BRIDGE NO. A23641

Job No. J8P0605E Letting Date 6/26/2009 Construction Plan Changes

This change order was required because of the contractor's request to make all piles vertical.

Bridge A23641 - Sheets 30, 31, and 35

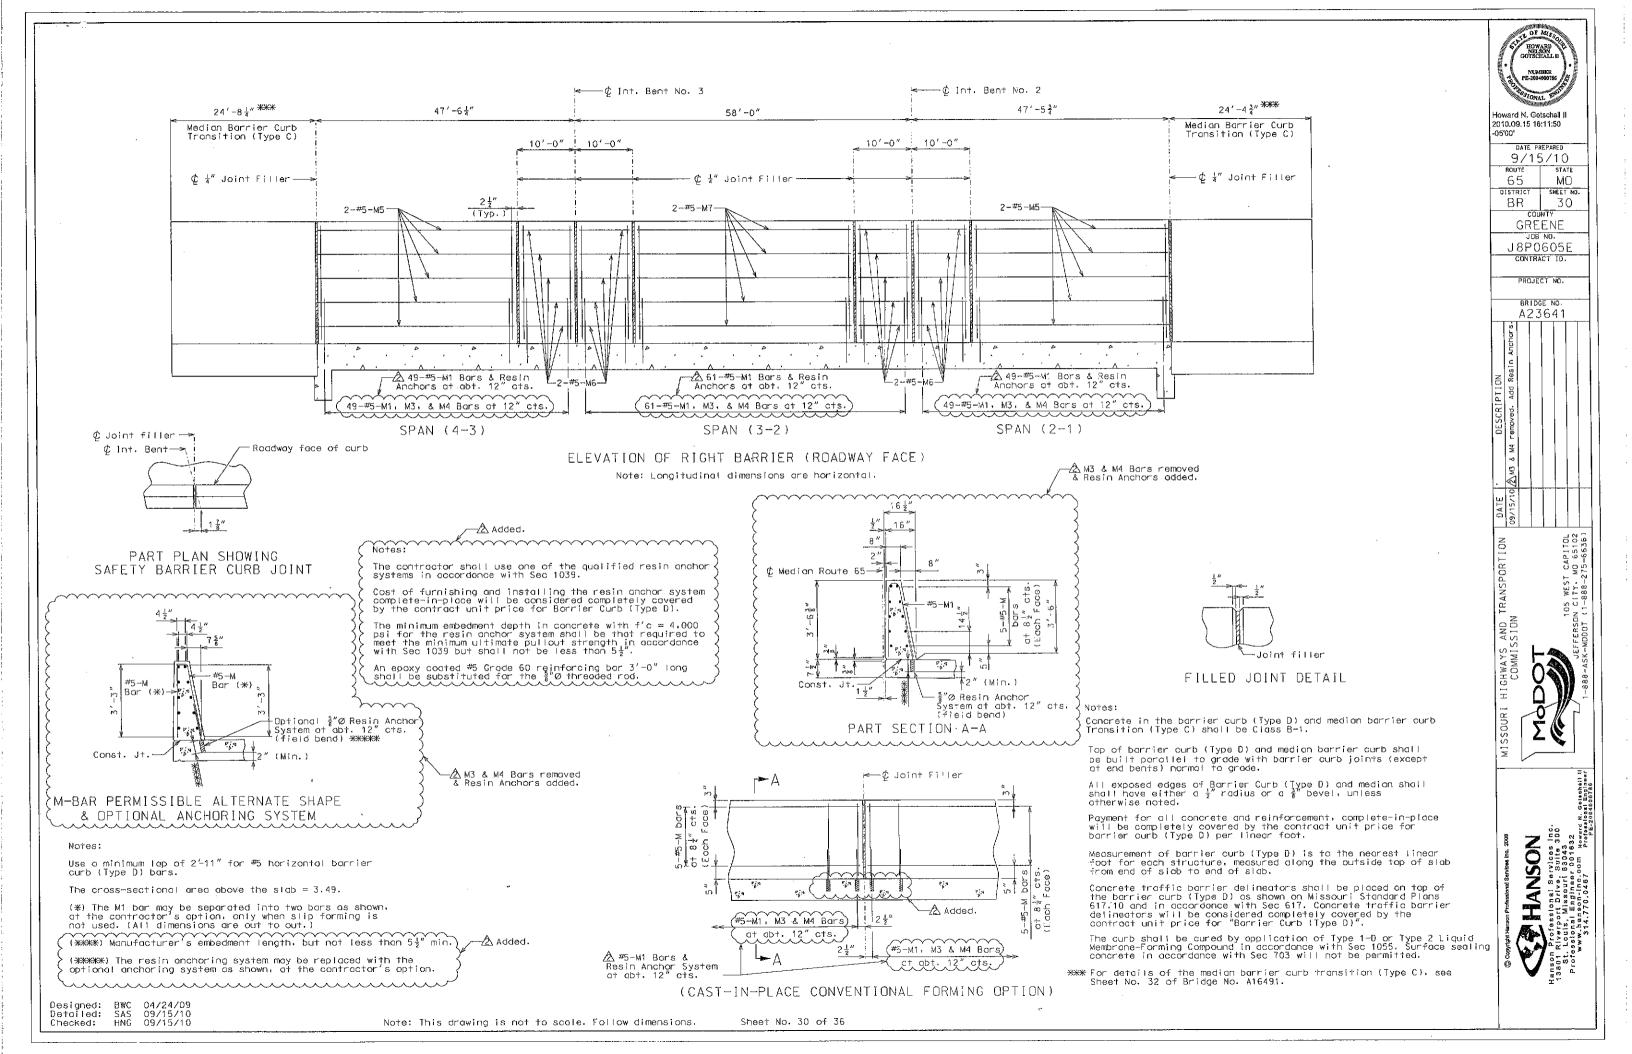
This change order was required because of the contractor's request to use resin anchors.

Bridge A16491 – Sheets 1, 11 and 13 Bridge A23641 - Sheets 1, 11 and 13

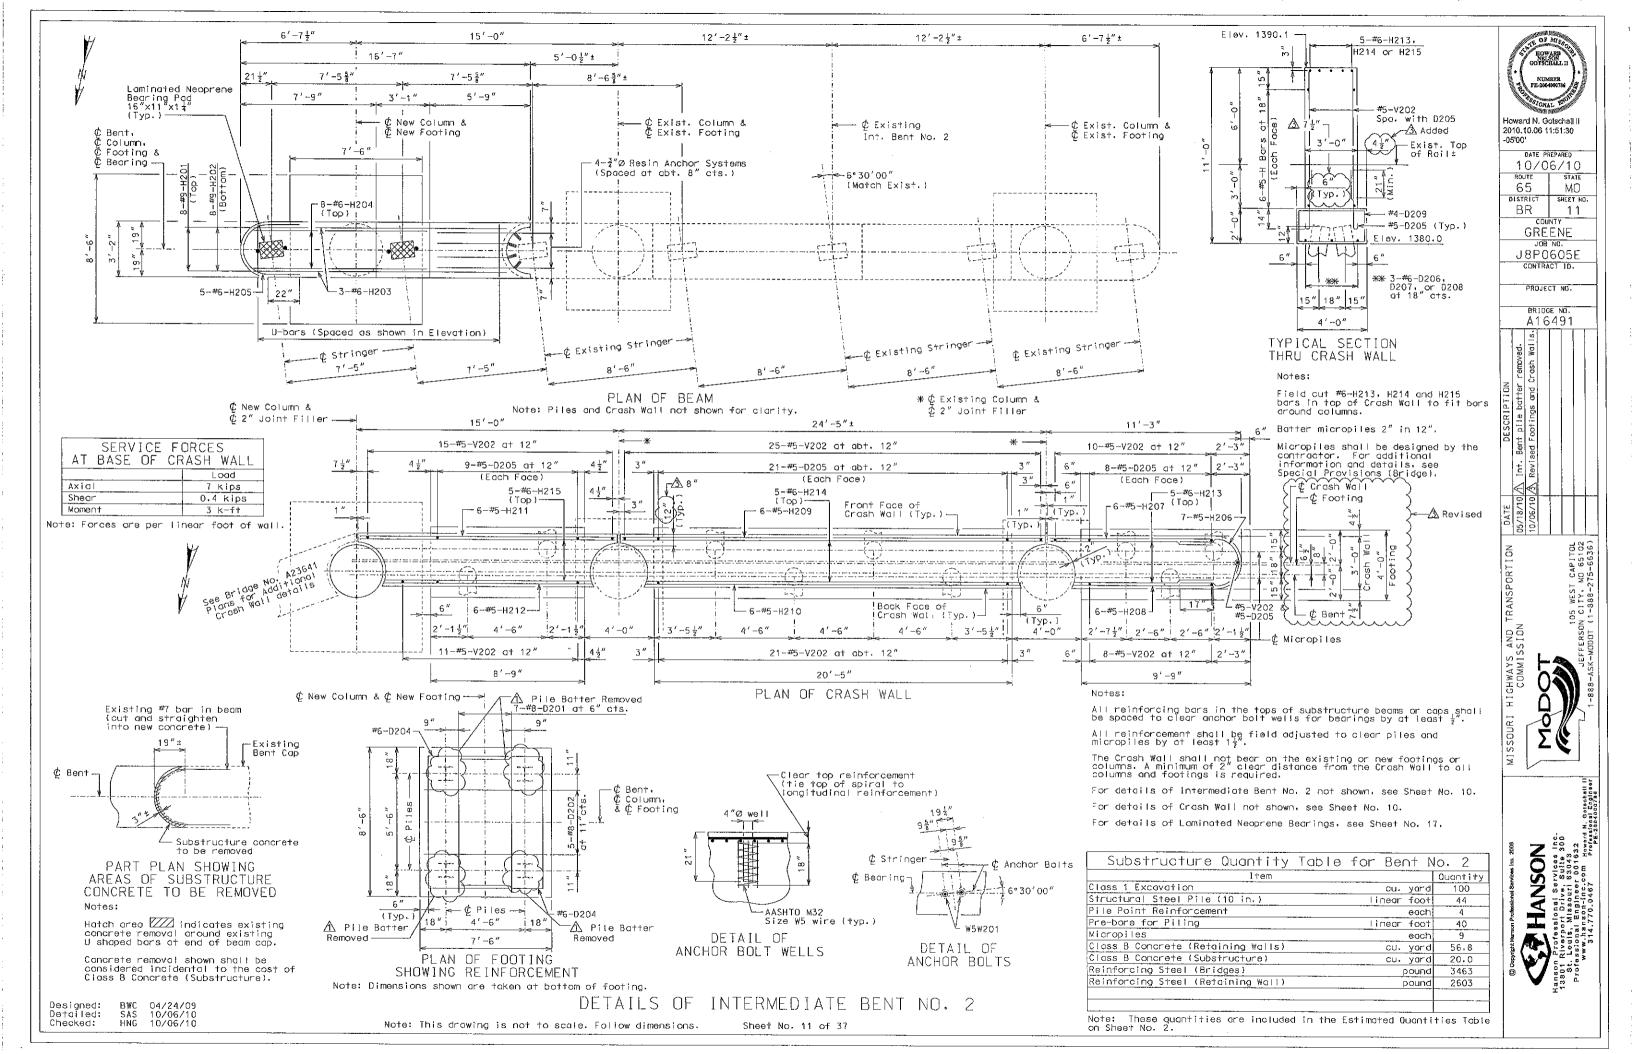
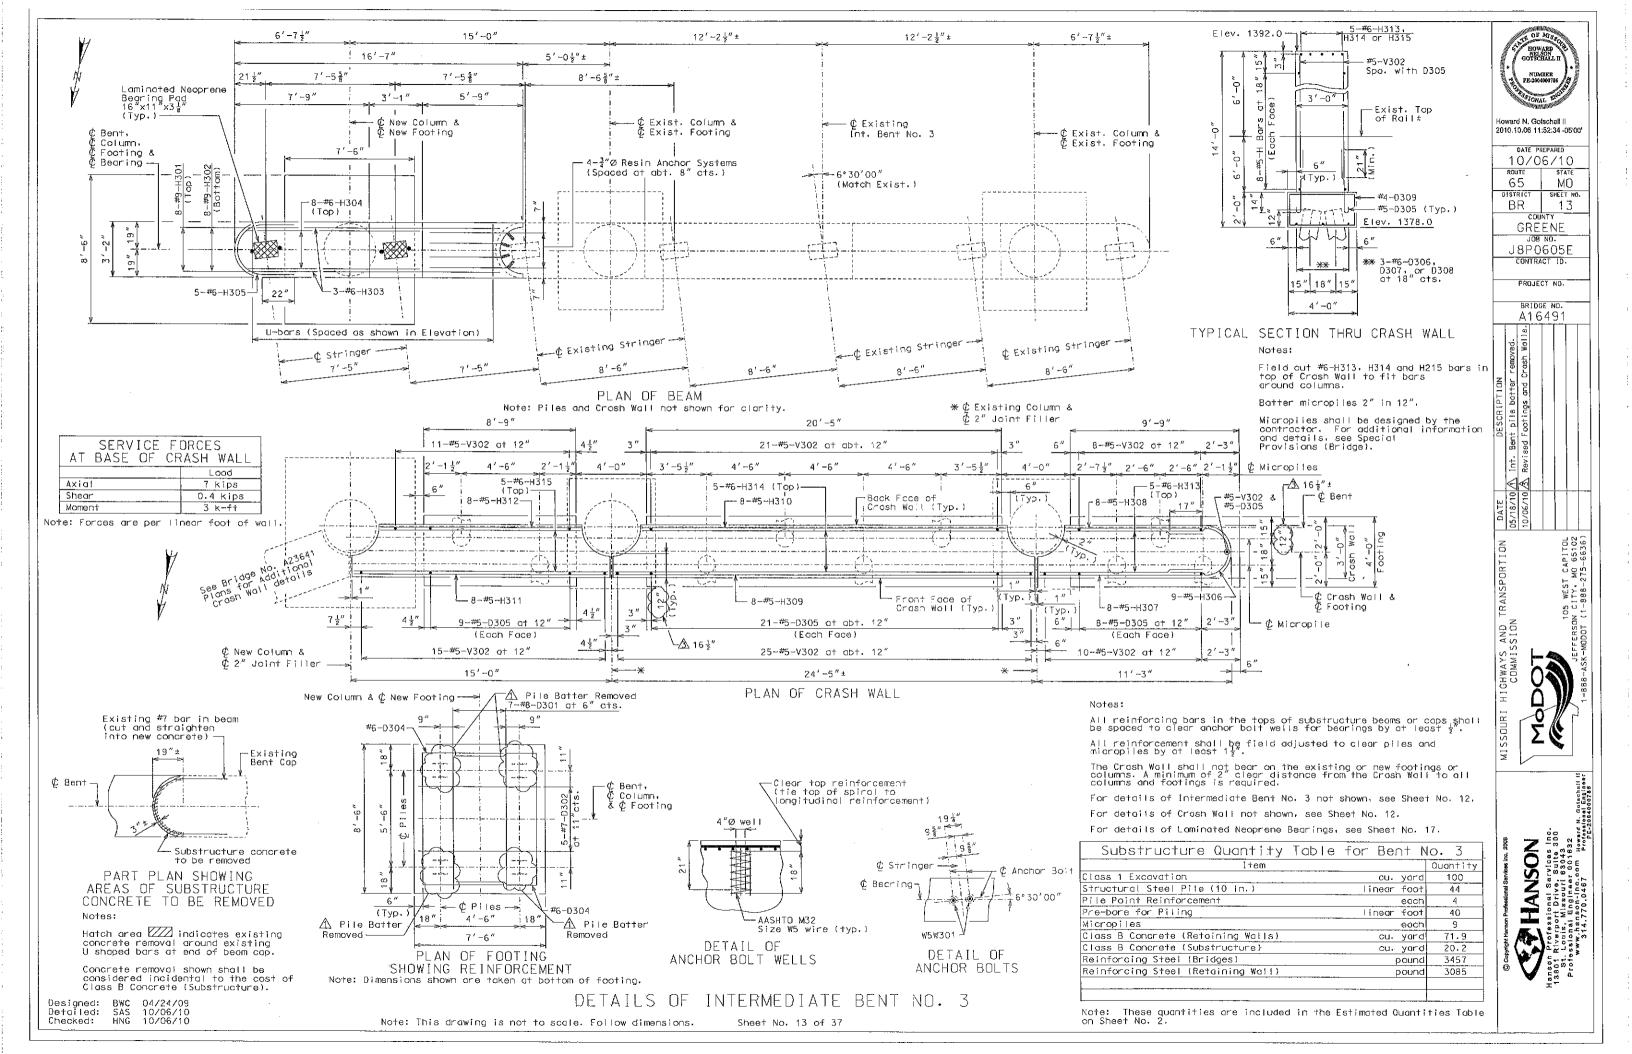
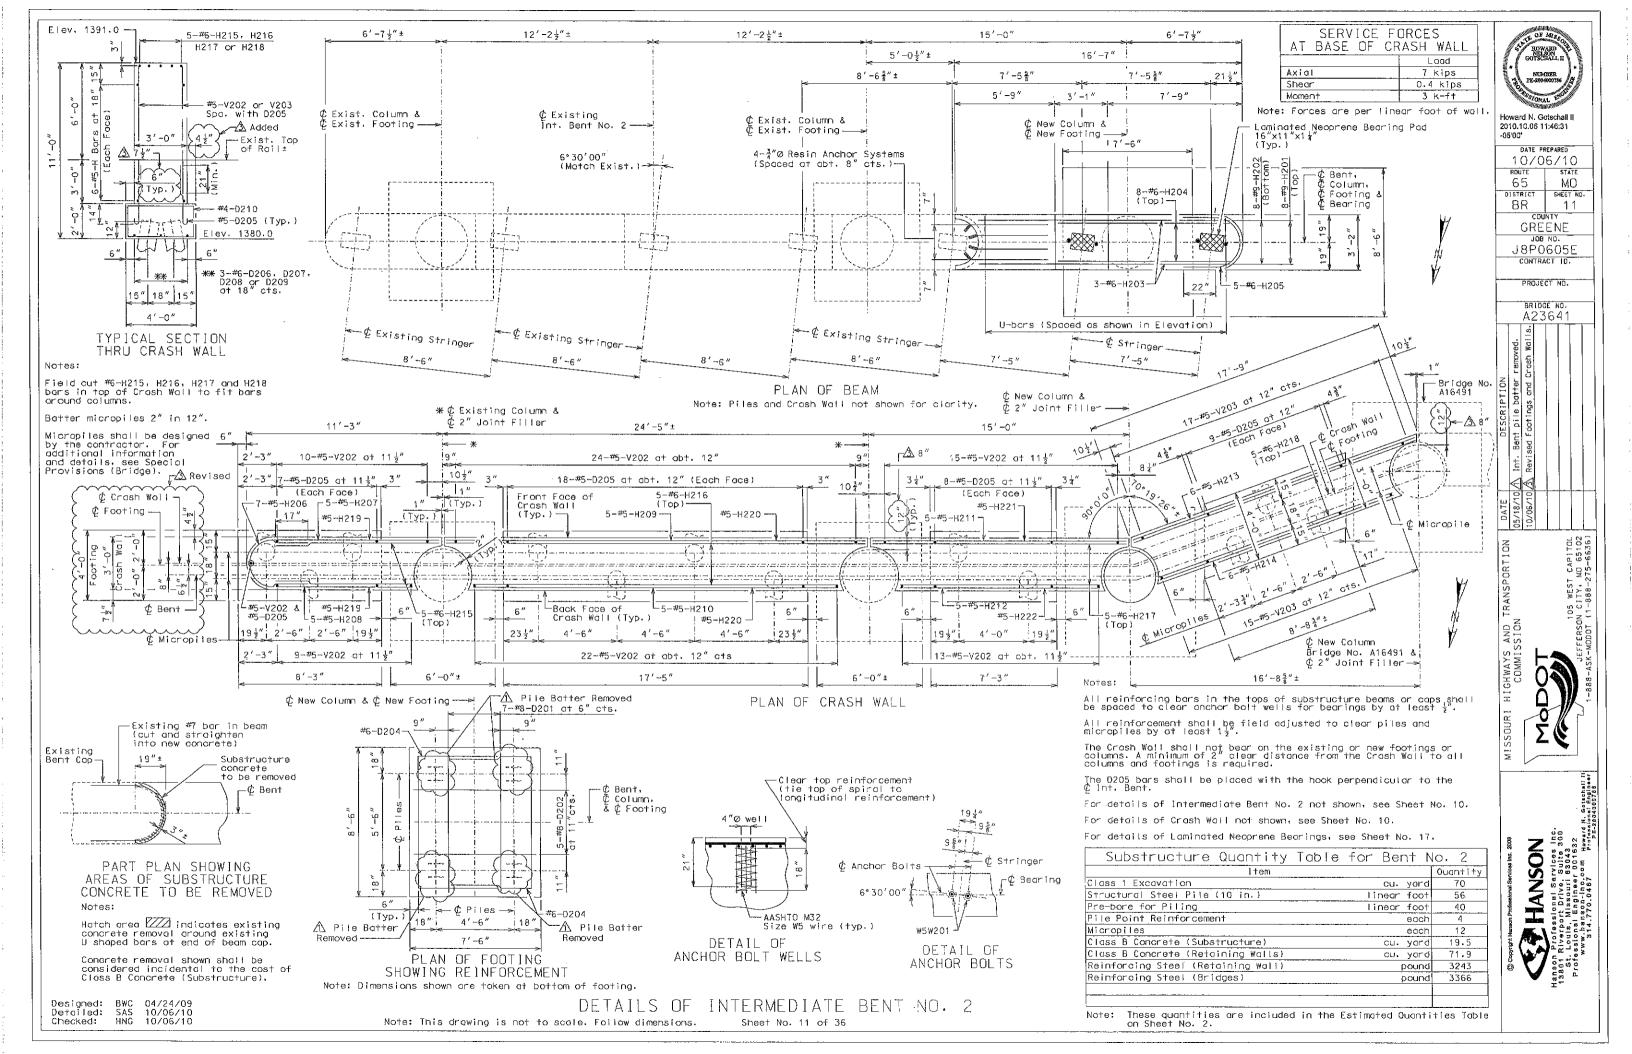
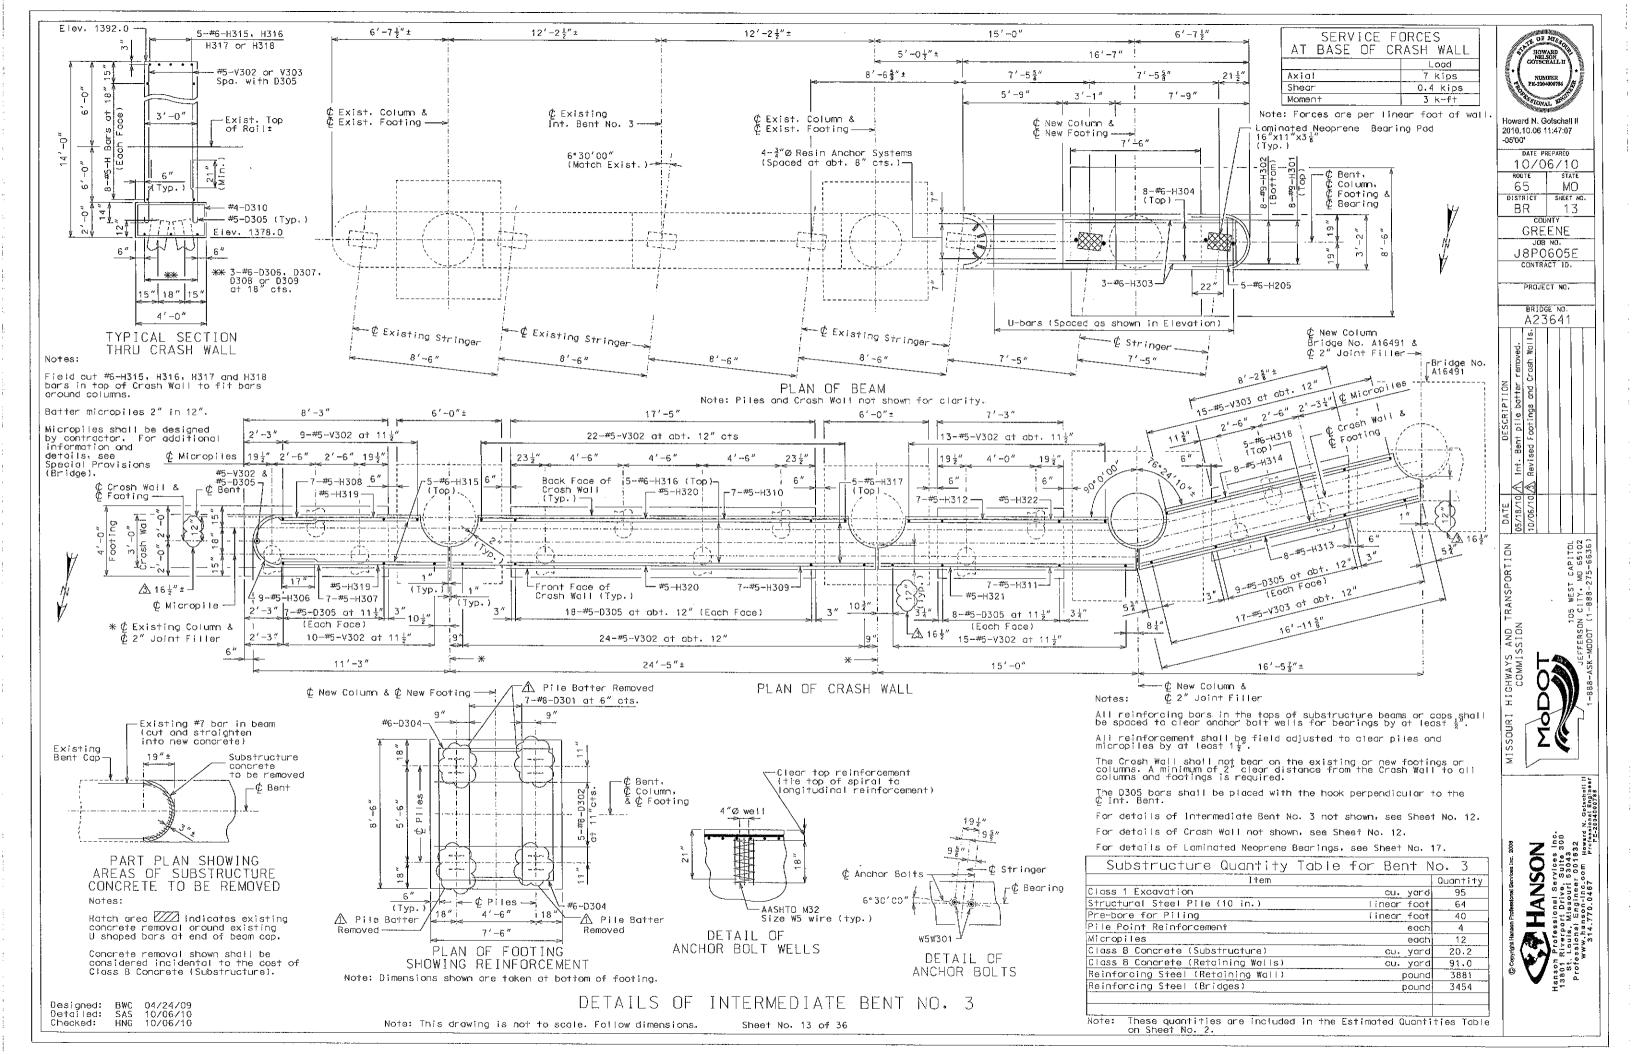
This change order was required because the micropiles were driven in the wrong location, which required changes to the crash wall and crash wall footing.
